**MAYOR'S REPORT & RECOMMENDATION IN ACCORDANCE
WITH SECTION 179 3(a) OF THE PLANNING & DEVELOPMENT
ACT 2000 (AS AMENDED)**

Re: Part 8 Proposal for the following:

The proposed works will include a) The demolition of the existing single storey dwelling (floor area 45.7 sq m). b) the construction of 6 no. 2 storey dwellings in two blocks consisting of 3 no. 2 bedroom dwellings and 3 no. 3 bedroom dwellings. c) Site and external works to consist of the removal of existing gates, front boundary wall and piers, the provision of 8 no. car parking spaces, one of which is reserved for wheelchair use, the provision of 6 no. covered cycle spaces, improvement of public realm areas to including the replacement of a footpath, connection to the existing foul and surface water network, and all other associated site development and landscaping works at Knock Hill, Ferndale, Caherdavin, Limerick.

Figure 2: Proposed Site layout

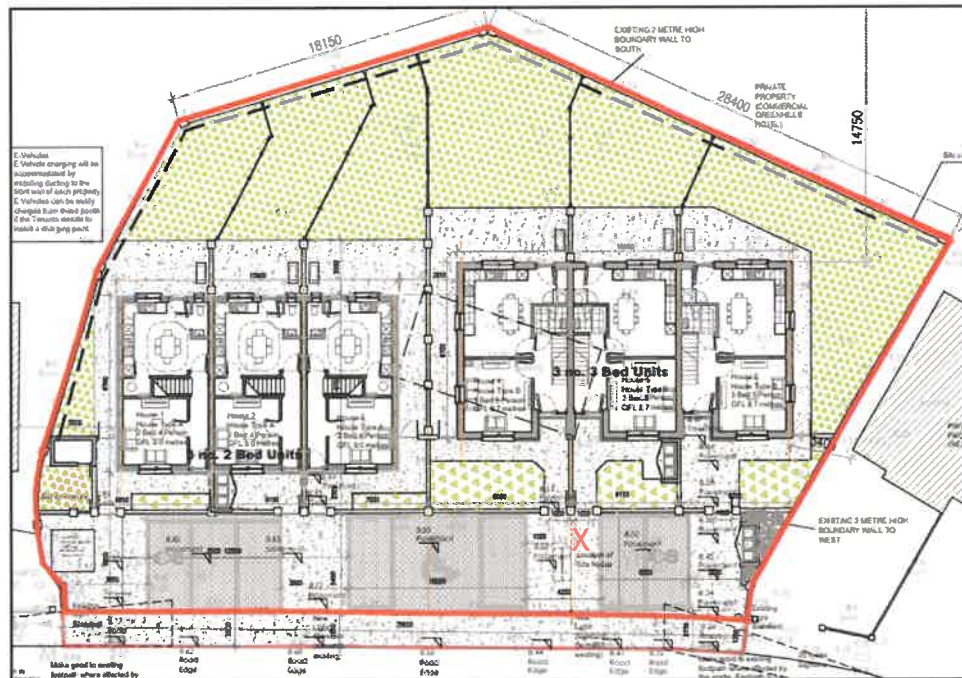
3. Secure Bin Store — Screening and Visual Impact The proposed secure bin store, as shown on the site layout plan, is positioned in a prominent location with direct visibility from the public footpath. No screening or landscaping treatment appears to be indicated in the drawings. It is requested that the applicant provides appropriate natural screening — such as hedging or climbing planting — to mitigate the visual impact of this structure on the streetscape and on adjoining residents.

There are three dedicated bin stores on site. Two are contained within the curtilage of their respective properties and one is located to the side of the public parking area. These bins (capacity 3 no. black/ green/ brown) will be located in a lockable secure binstore. The binstore will be part of a planter attached to the existing 2 m high western boundary wall. The planting as well as the fact it is located away from the pedestrian footpath will lessen its impact. I will include an image below for clarity.
